Access Compliance Report

Public Rights-of-Way

(Curb Ramps)

Intersection ID: 10024489	Main Street: CROWN_CRESCENT_CT	Cross Street: N/A	Location: NW
ADA ID: 6855BAC1116A	Ramp Type: ParaDiag	Initial Pass/Fail: Fail	Overall Compliance: No
Severity Score: 26.25			
Codes/Mitigation Info/Possible Solution		Field Measurements/Component Compliance

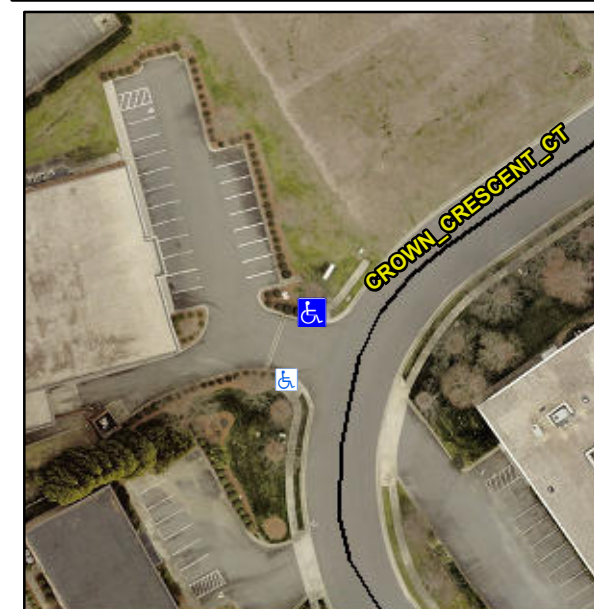
R304.3.2, R304.5.3

Compliance	Description	Data	Compliance	Description	Data
N/A	Ramp Length LT (in)	64.5	N/A	Ramp Length RT (in)	51.0
Yes	Ramp Width LT (in)	88.0	Yes	Ramp Width RT (in)	90.0
No	Ramp Slope LT (%)	19.9	No	Ramp Slope RT (%)	13.6
No	Ramp XSlope LT (%)	3.4	Yes	Ramp XSlope RT (%)	0.5
N/A	Landing Length (in)	N/A	N/A	DWS Provided?	N/A
N/A	Landing Width (in)	N/A	N/A	DWS Contrast?	N/A
N/A	Landing Slope (%)	N/A	N/A	DWS Length (in)	N/A
N/A	Landing X Slope (%)	N/A	N/A	DWS Full Width?	N/A
N/A	Landing Curb? (Y/N)	N/A	N/A	DWS Offset (in)	N/A
N/A	Shared Landing?	N/A			
N/A	Gutter Ponding?	N/A	N/A	Gutter Slope (%)	N/A
N/A	Gutter Lip Ht (in)	N/A	N/A	Gutter X Slope (%)	N/A
N/A	Painted X Walk1?	No	N/A	Painted X Walk2?	No
	X Walk 1 Direction	To SW		X Walk 2 Direction	To SE
N/A	X Walk 1 Width (in)	N/A	N/A	X Walk 2 Width (in)	N/A
	X Walk 1 Slope (%)	0.4		X Walk 2 Slope (%)	12.4
	X Walk 1 X Slope (%)	14.4		X Walk 2 X Slope (%)	2.9
N/A	Ramp inside XWalk1?	N/A	N/A	Ramp inside XWalk2?	N/A

Road Slope (%)	16.6	N/A	Clear Space?	N/A
	Road X Slope (%)	2.9	N/A	Clear Space to XWalk (in)	N/A
N/A	Any Obstructions?	N/A	N/A	Storm Grate/Utility Hazard?	N/A
	Obstruction Type			Storm Grate/Utility Type	
		N/A			N/A
			Yes	Surface Condition? (G/P)	Good
			N/A	Curb Slope (%)	4.3

Remove & Replace Curb Ramp With Two New Directional Ramps or Equivalent.
